APPENDIX 9-A

OPRHP Correspondence

SOLAR FACILITY ARCHAEOLOGY COMMENTS

Project: Somerset Solar Project (140-200 MW/? acres)

AS SHOWN
SHEET NO: **PV-C.02.02** REV: **A**

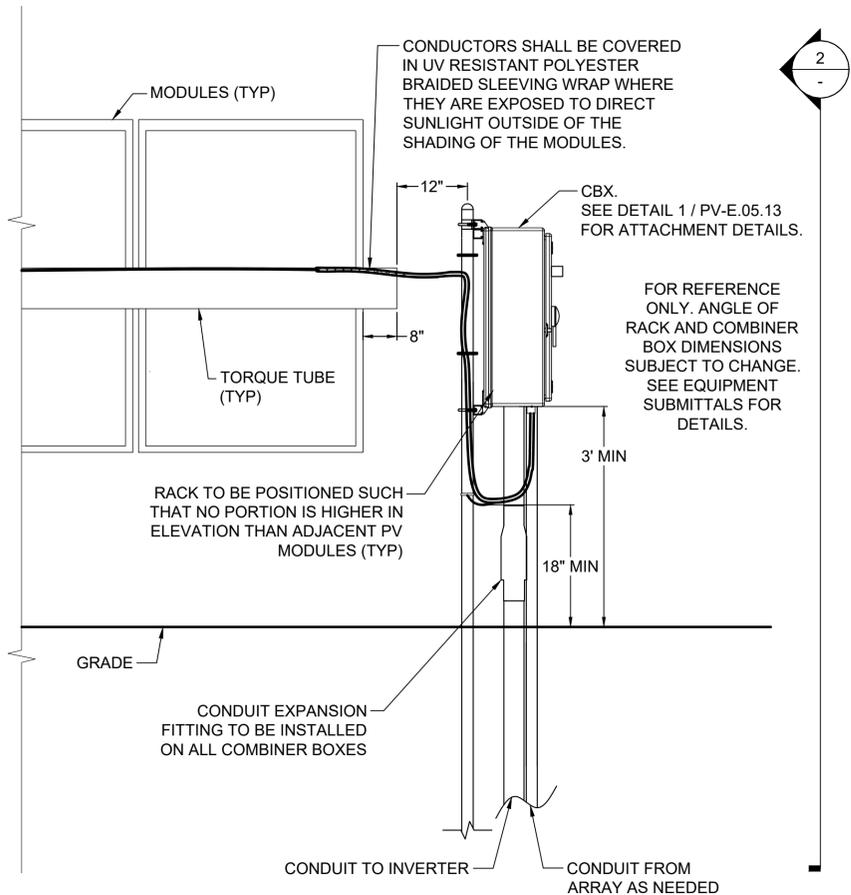
1. Detailed site plans showing solar panels, access roads, and other features, as well as any existing or proposed vegetative or topographic buffers, in the immediate vicinity of the Smith Residence and Babcock House. (It is useful for these plans to be superimposed with satellite or orthographic images.) Please also include, elevation drawings of the solar panels indicating maximum panel height and direction of rotation.

Response: The requested site plans (superimposed over aerial imagery) and elevation drawings are included in Attachment A, and include a site plan overview (PV-C.02.00), site plans for the Facility areas in the vicinity of Smith Residence (PV-C.02.01) and Babcock House (PV-C.02.02), and Conduit Management Standards (1 of 3 and 2 of 3) (PV-E.05.11 and PV-E.05.12). Both fixed tilt and single-axis panels are proposed, with fixed tilt panels having a maximum height of 7.14 feet from grade, and single-axis panels having a maximum height of 10.24 feet (maximum) from grade. The single-axis panels will be
